**APPROVED PLANNING 2015/0331/P**

**PROPOSED PLANNING 2016/0992/P**

(Drawing Name A-1103\_Rev 01 proposed level 02-03-04)

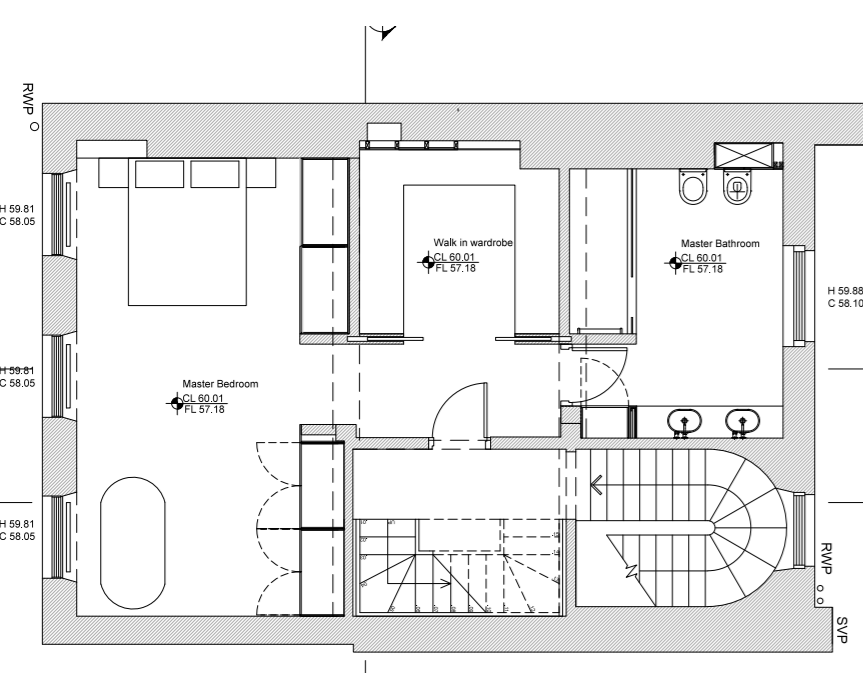
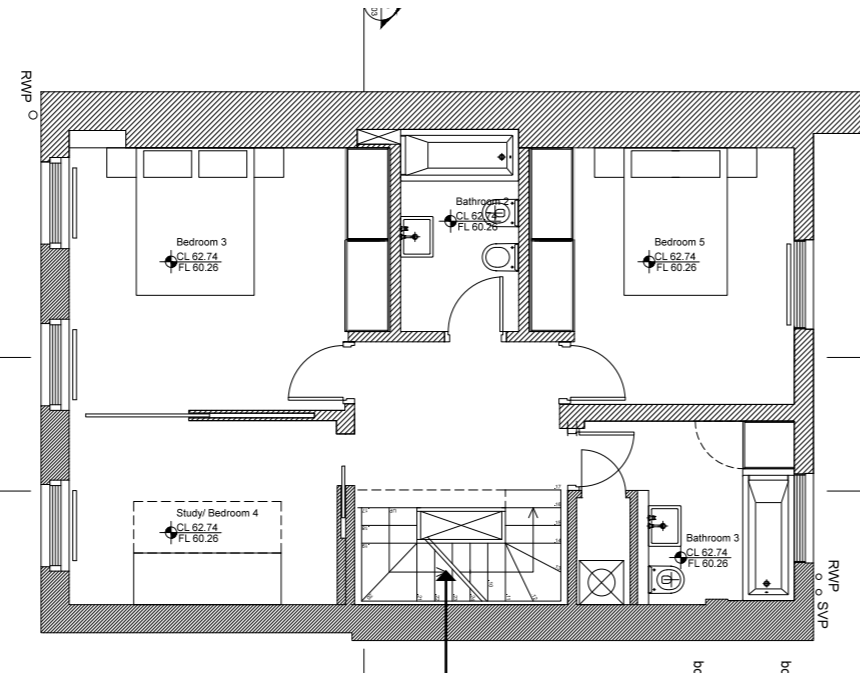
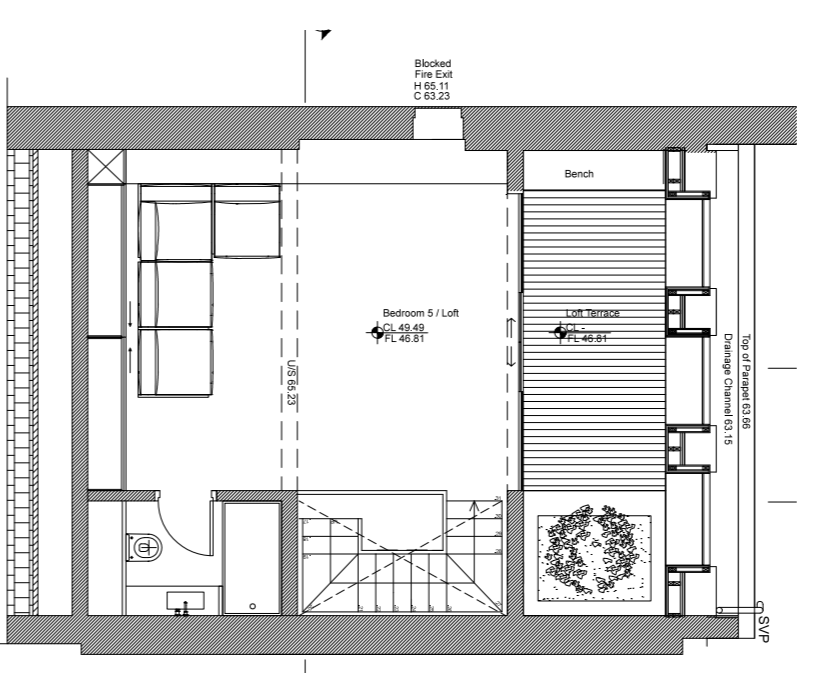
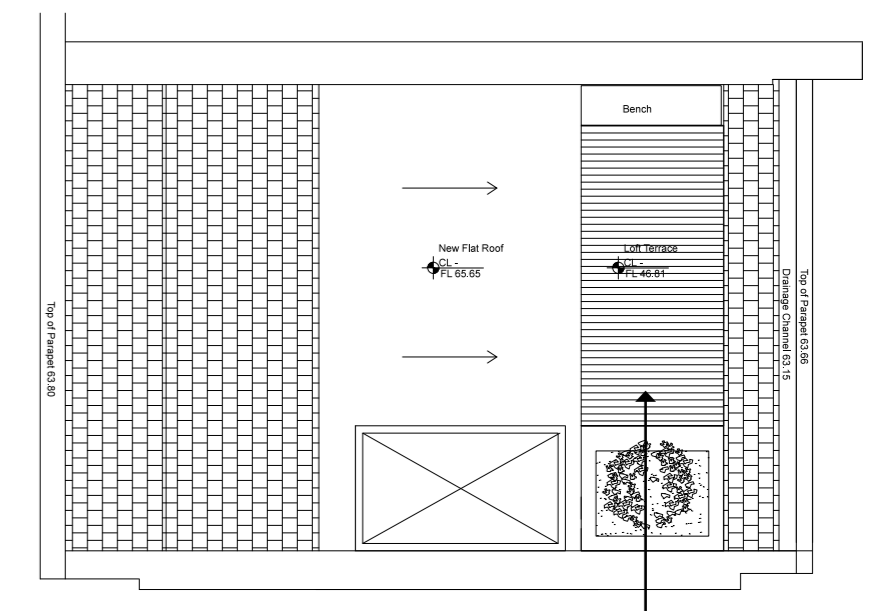
We propose to keep the stairwell in the existing position in order to not interfere with the structure of the building.

we keep the approved terrace aligning it with the roof original structure
